1 Q. Reference: Study, Section 9, page 34, figure 6

**Figure 1: Labrador Industrial Customer Incremental Demand Charge**

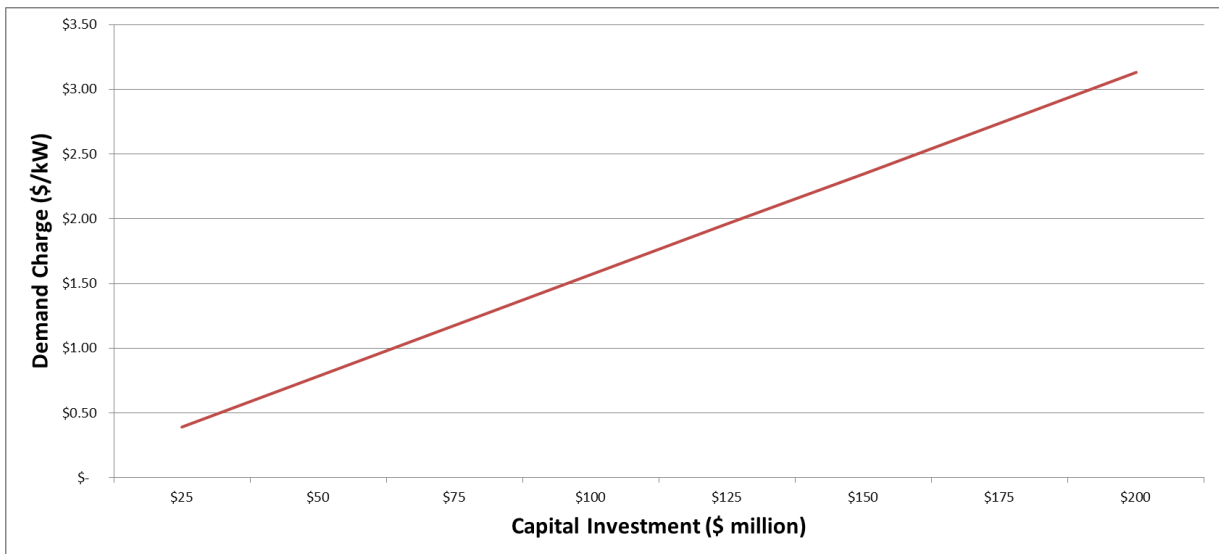
3 Please provide figure 6 in "\$/kW-month" instead of "% increase" for Industrial customers.

6 A. Please refer to Figure 1. The \$/kW month incremental demand charge represents the  
7 increase in the transmission demand charge for each amount of capital investment  
8 provided on the X-axis.
